Docket No. 217 - Development and Management Plan Inspection

Northeast Utilities Service Company Certificate of Environmental Compatibility and Public Need for the construction of a 345-kV electric transmission line and reconstruction of an existing 115-kV electric transmission line between Connecticut Light and Power Company's Plumtree Substation in Bethel, through the towns of Redding, Weston, and Wilton, and to the Norwalk Substation in Norwalk, Connecticut.

Date: May 4, 2006

Location: Overhead Line (Composite 345kV and 115kV Gallows Hill to Archers Lane,

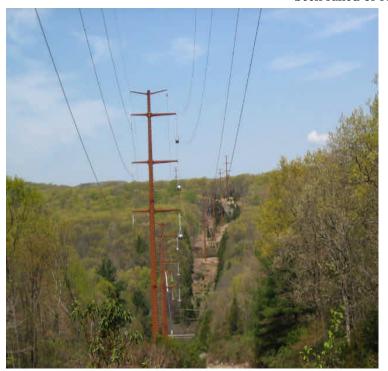
(Composite Section-Archers Lane): Photo on the left shows a view of third wetland crossing. Erosion controls remain intact but the wetland has not been restored. It may no longer be necessary. Photo on the right shows one of the areas off the ROW where wood chips have not been raked or removed. 5/04/06
